Comments on the TG1 Specification

Subir Varma

Aperto Networks

MAC Packet Encapsulation

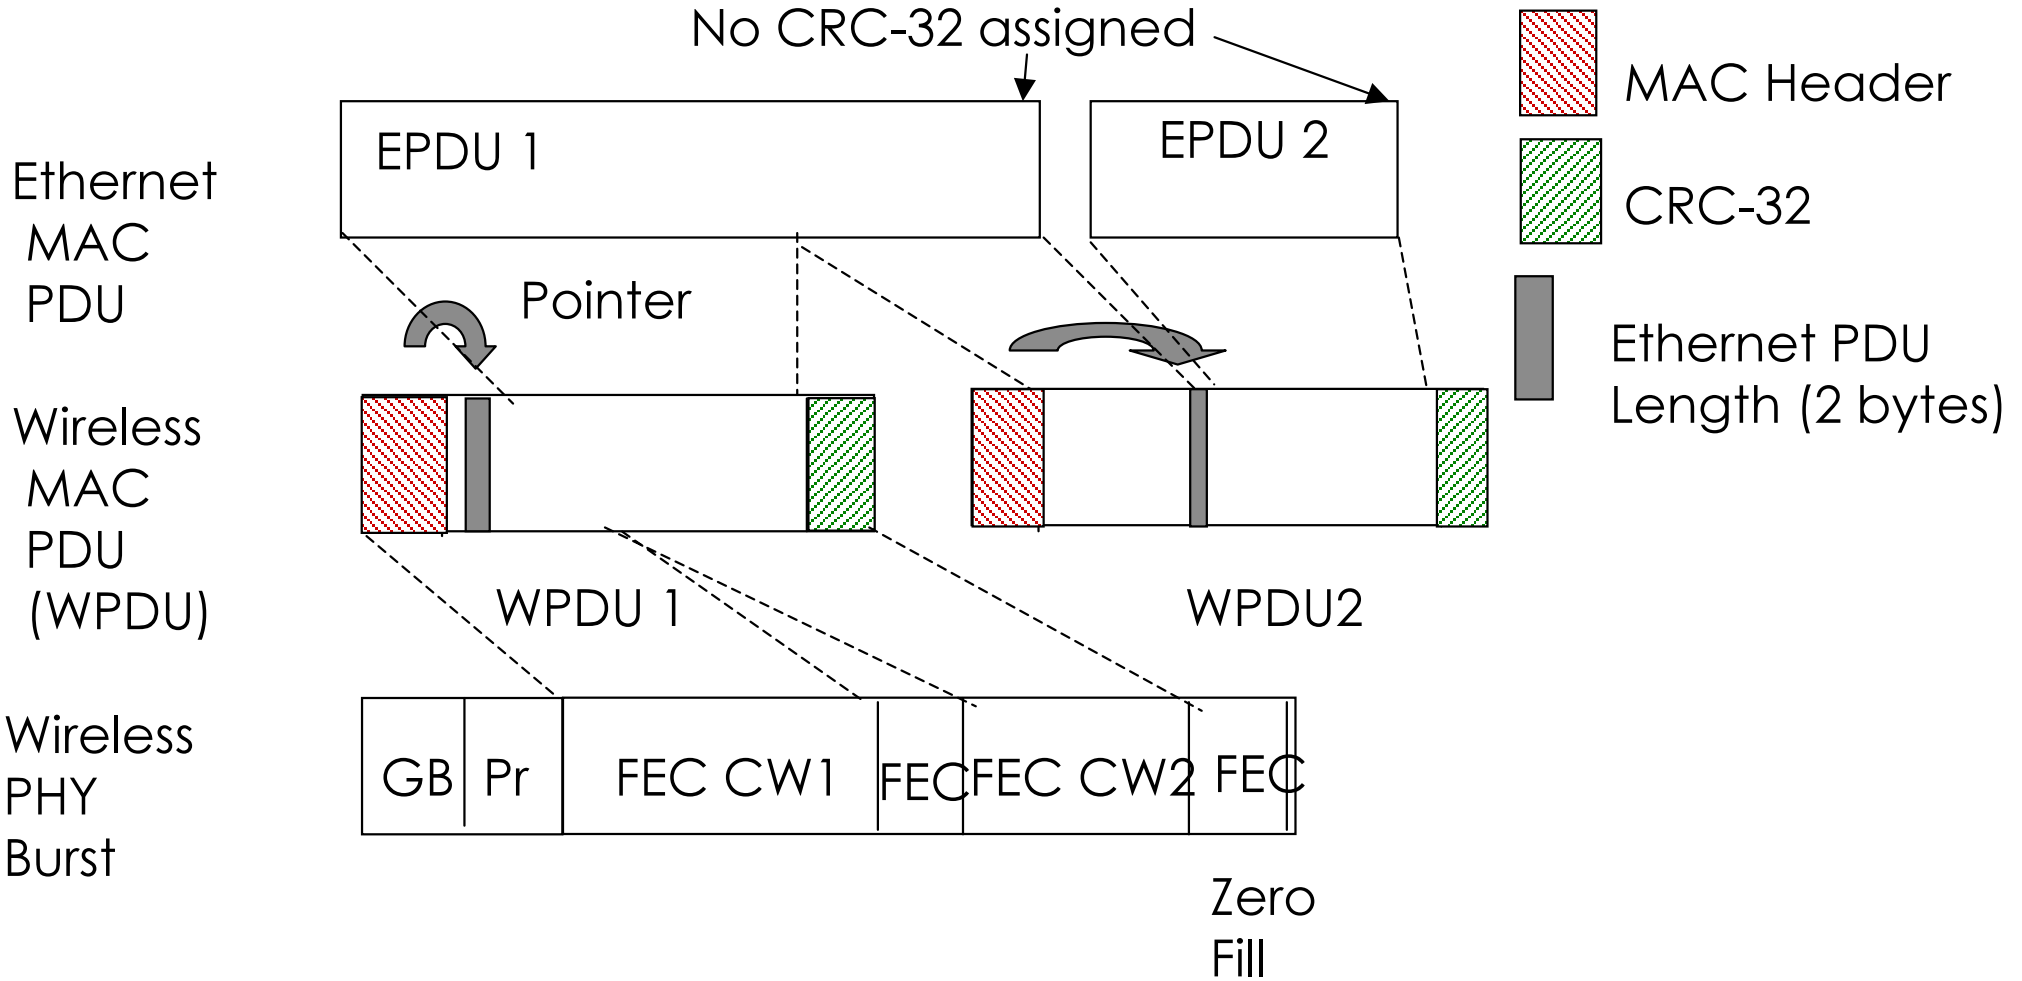
■ **Shortcomings of current TG1 design:**

- ❑ **Does not support concatenation efficiently. Essential to the efficient operation of the TCP protocol**
- ❑ **Does not have a large enough Piggyback request field to be able to efficiently handle short bursts of data**

■ **Suggestion:**

- ❑ **A simple pointer based encapsulation scheme, that supports both concatenation and fragmentation**
- ❑ **Increase the Piggyback request field size to 2 bytes**
